Title of Change:	Update to FPCN23609X: Removal of products listed in the original FPCN "Second source site addition for final test and shipping tray change for AR0330 CSP products."
Proposed First Ship date:	23 Apr 2021 or earlier if approved by customer
Contact Information:	Contact your local ON Semiconductor Sales Office or Geethakrishnan.Narasimhan@onsemi.com
PCN Samples Contact:	Contact your local ON Semiconductor Sales Office or <PCN.samples@onsemi.com> . Sample requests are to be submitted no later than 30 days from the date of first notification, Initial PCN or Final PCN, for this change. Samples delivery timing will be subject to request date, sample quantity and special customer packing/label requirements.
Additional Reliability Data:	Contact your local ON Semiconductor Sales Office or Amy.Wu@onsemi.com
Type of Notification:	This is a Final Product/Process Change Notification (FPCN) sent to customers. FPCNs are issued 90 days prior to implementation of the change. ON Semiconductor will consider this change accepted, unless an inquiry is made in writing within 30 days of delivery of this notice. To do so, contact PCN.Support@onsemi.com

PCN#: FPCN23609X1
Issue Date: Mar 30,

Original Case Outline Drawing (2inch Tray)

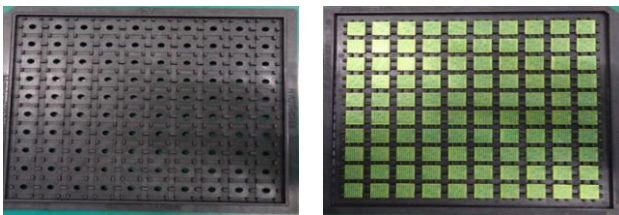
There is no product marking change as a result of this change. The difference in appearance of the tray is shown below.

2inch : 5*5=25ea

4inch : 10*10=100ea
